**CYPRESS POINTE**  
**SUBDIVISION OBSERVATION REPORT**

**July 25, 2012**

**HR GREEN JOB NO. 86120056**

CYPRESS POINTE  
 LOT 33

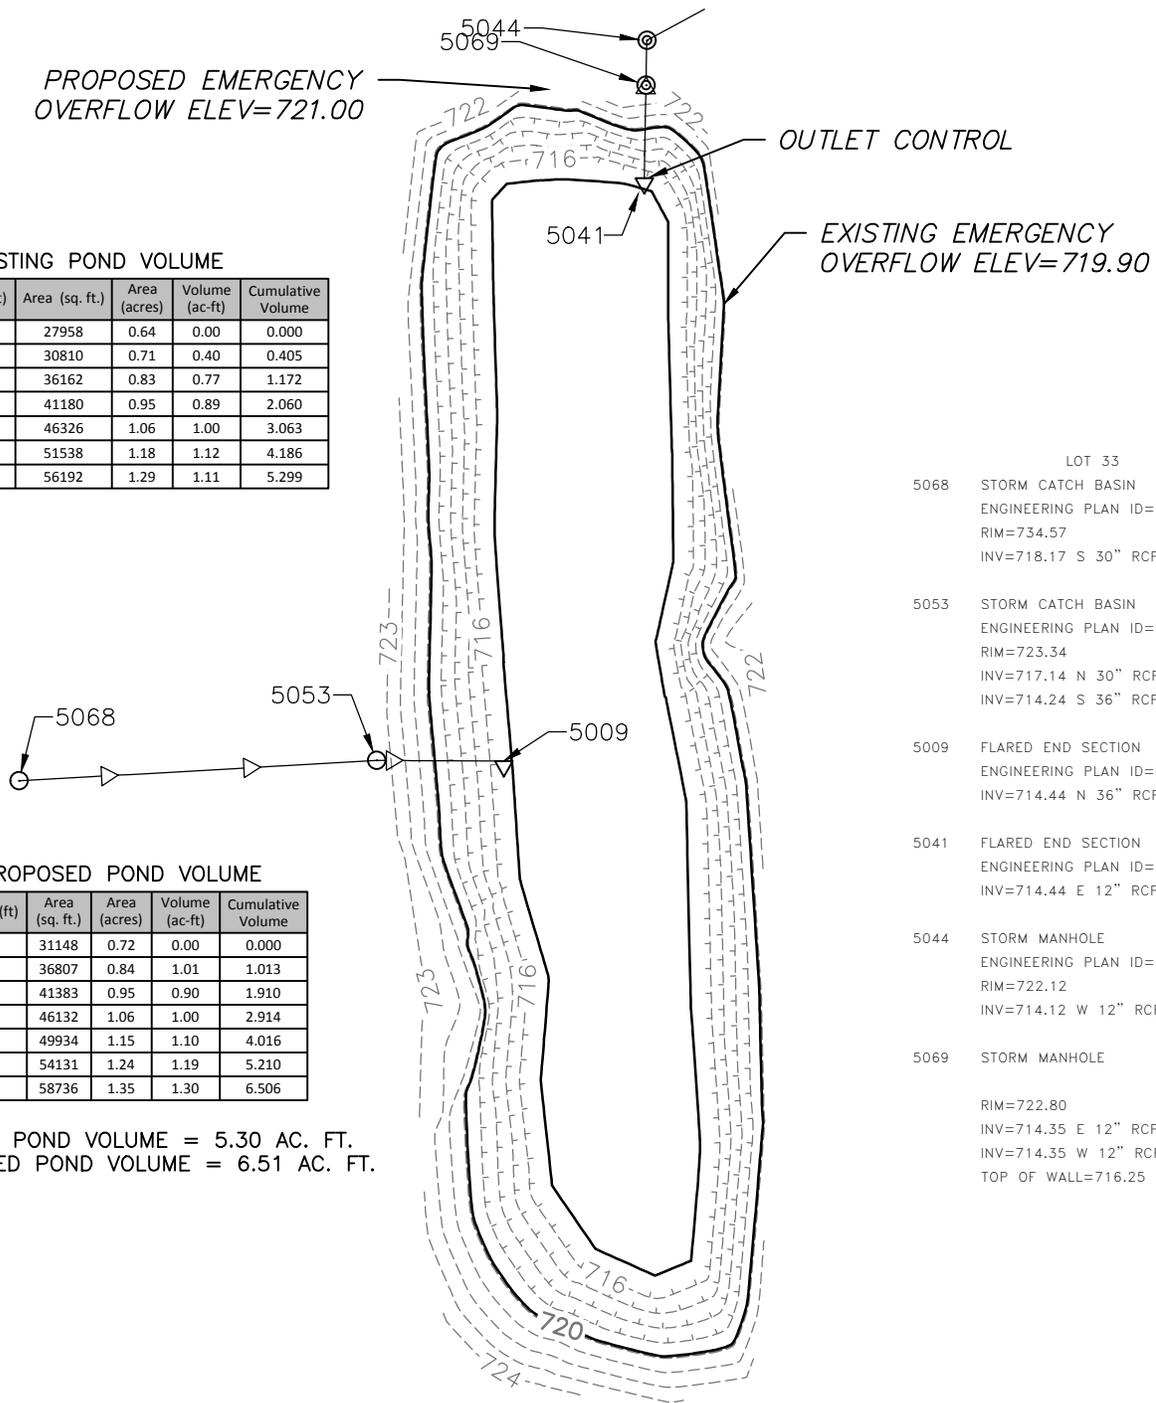
The weir wall within the restrictor manhole and the 100-year restrictor orifice were constructed 0.20' and 0.15' low respectively. The 2 and 100 year orifice elevations and sizes could not be verified. The known deviations would result in a stormwater release rate that is greater than the rate proposed. The existing 100-year emergency overflow was found to be in an alternate location and at an elevation 1.1' lower than proposed. This results in a reduced storage volume for the basin. Based on the information available we were able to determine that the existing pond has 1.21 ac.ft. less storage volume than proposed. This basin does not comply with the design plans. Our analysis concludes that the existing pond is 19% short of the proposed storage volume. If corrective measures are deemed necessary, adjustments to the overflow weir or outfall pipes can be

evaluated. A detailed analysis of the original design calculations and existing site conditions would be necessary. HR Green can provide this service for an additional cost.
